This errata sheet provides information about known device issues affecting Stratix® V production devices.

Production Device Issues for Stratix V Devices

Figure 1. ATX PLL Left and Right Sides**Unused or Idle Clock Performance Degradation**

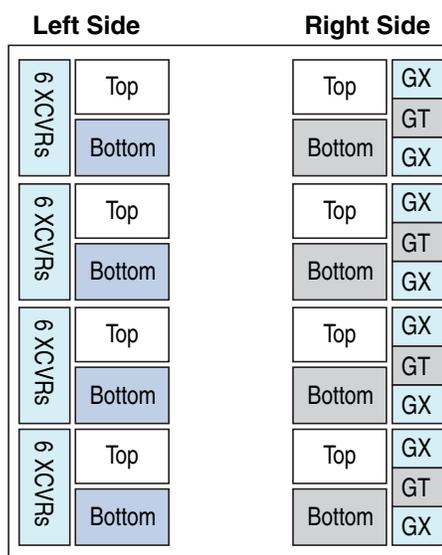
The ATX PLL range is limited for Stratix V production devices. [Table 3](#) through [Table 7](#) list the specifications for these devices.

You must ensure that the correct ATX PLL location is assigned, based on the data rate desired and the specifications listed in [Table 3](#) through [Table 7](#).

(2) Refer to Figure 1 for the Left side and Right side positions.

- (1) “L” is the post VCO Divider within the ATX PLL. The Local/Central Clock Divider is located within the channel.
 (2) Refer to Figure 1 for the Left side and Right side positions.
